**Project Metrolink Railway Order  
Estuary to Charlemont via Dublin Airport  
(ABP-314724-22)**

Statement of Evidence

Tunnelling Induced Ground Movements & Building Damage Assessment for the  
**Cadenza Building**, Earlsfort Terrace, Dublin 2

**Lowered Tunnel Level**

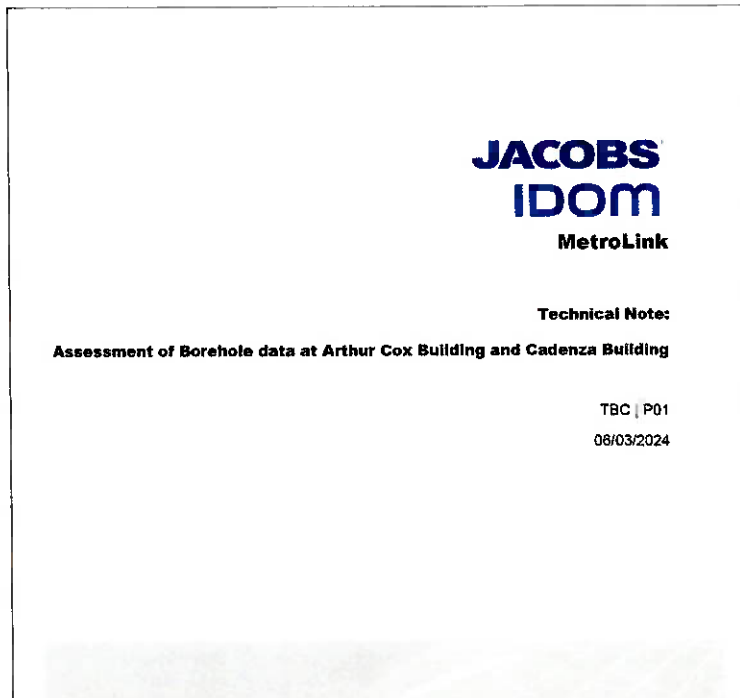
- Overall Damage Risk Category = 1/2 (Very Slight to Slight) => **Damage Level understated in EIAR Addendum**
- No Assessment of perimeter secant pile wall at lower foundation level – slightly higher settlement & distortion

Figure 4-1 Site Investigation Location Plan [from Figure 20.6 (Sheet 7 of 8) in Chapter 20 of the EIAR]

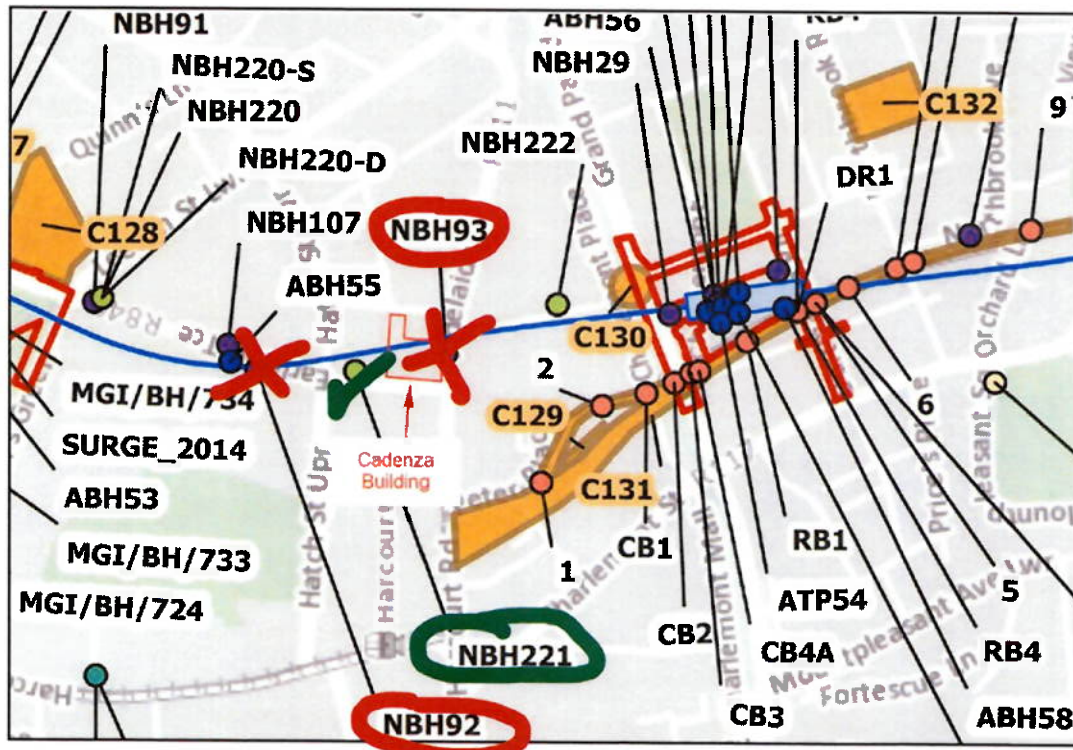
- NBH92 & NBH93 do not exist
- Borehole NBH-221 only Metrolink SI data relevant to Cadenza Building.
- SI Location plan in the EIAR should be updated (Ch. 20)

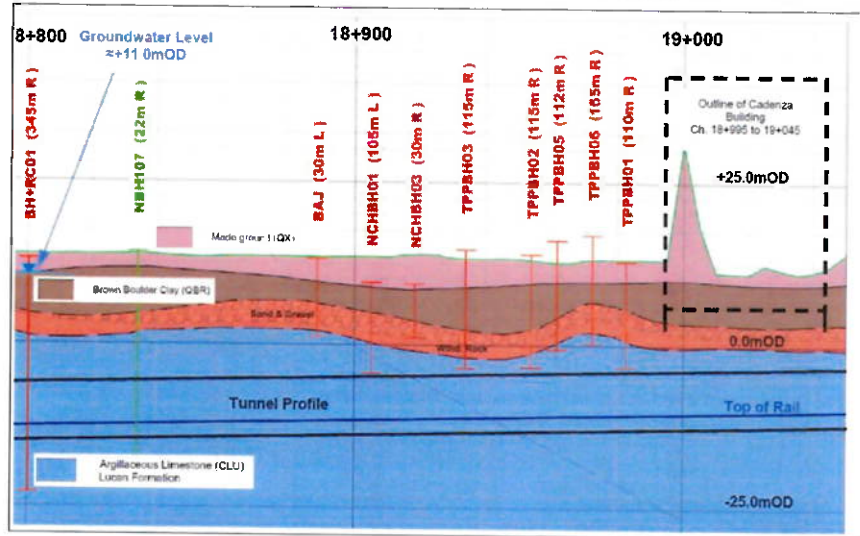
- Geological Profile in Appendix A20.9 of the EIAR shows rock at **+0.0mOD** under Cadenza Building & between **- 2.5mOD** and **+2.0mOD** under Arthur Cox Building.
- Top of competent rock at **+6.25mOD** in Borehole NBH-221
- Geological profile in EIAR is incorrect and should be updated to reflect actual rock levels - Relevant to further Phase 3 assessment and construction monitoring
